Historical Areas Board of Review(HABR)

PROPERTY ADDRESS: 17 Kopac Lane, Palisades, NY Section/Block/Lot: 78.13-1-3.9

Project Name: Tramutola Residence

Amendment to HABR # 22-17 dated July 12, 2022

SECTION/ELEVATION
SCALE 1/4" = 1'-0"

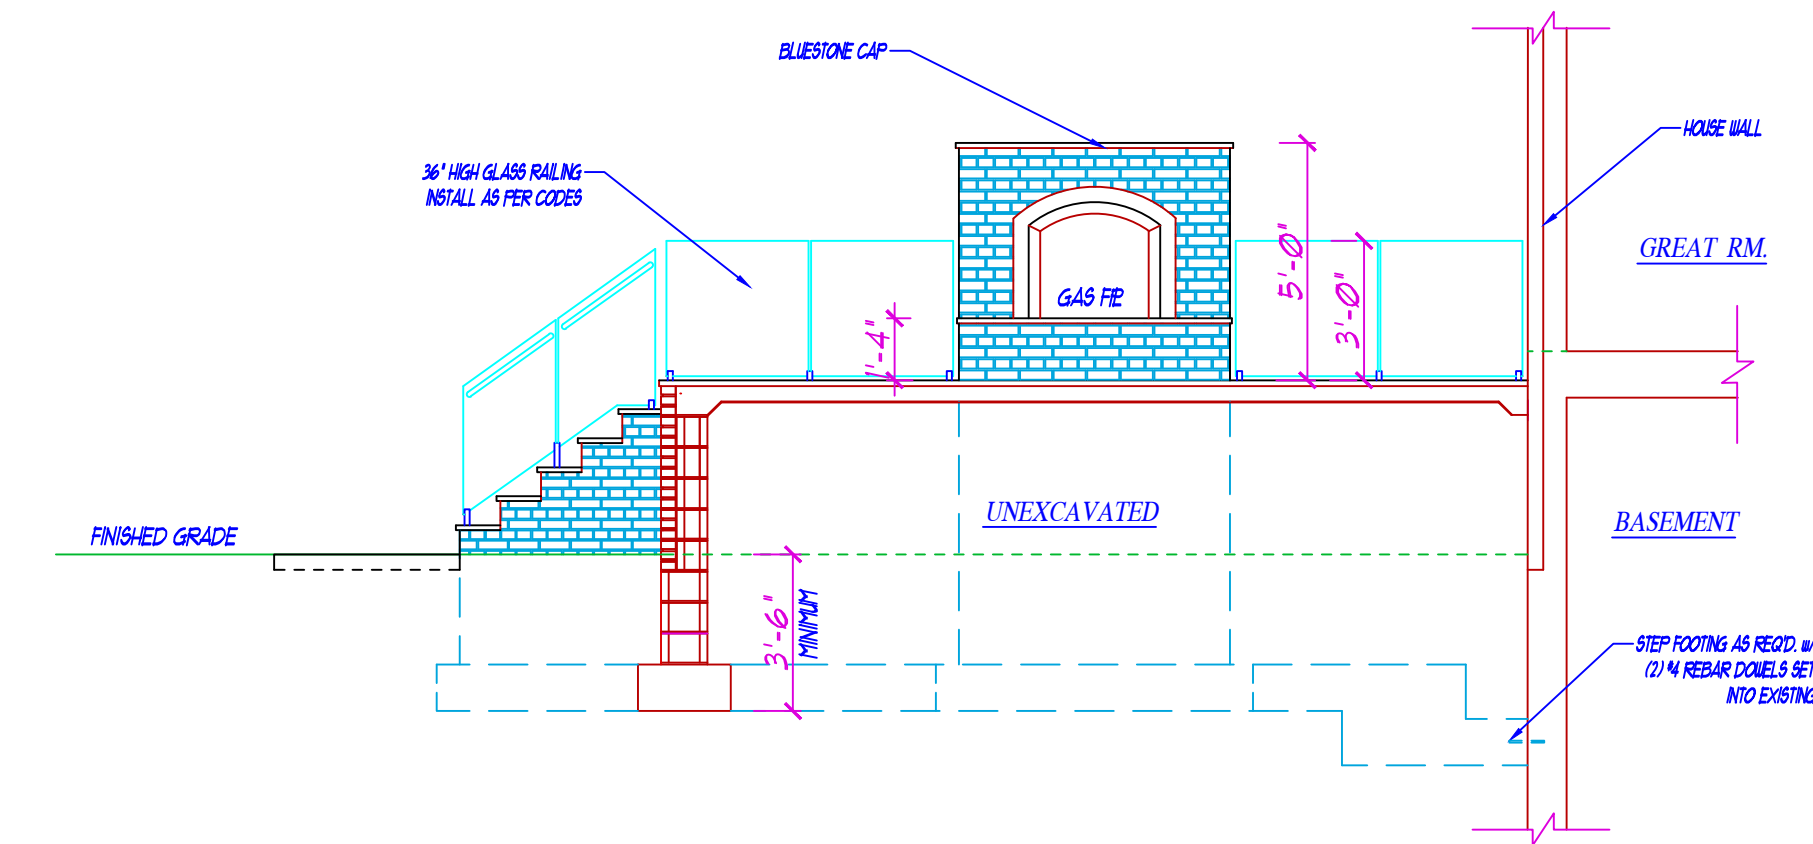
12. The Rear patio to be built with concrete & brick Cambridge® Sigma split face wall blocks and the patio surface to be bluestone Cambridge LedgeStone 3-pc paver. The color for both is Toffee/Onyx. The patio face will now be the same brick as the house, and the patio surface is bluestone flagging. As indicated in #1 above, a gas fireplace with a brick exterior will be built on the perpendicular north side of this patio. A fireplace design example picture is provided.
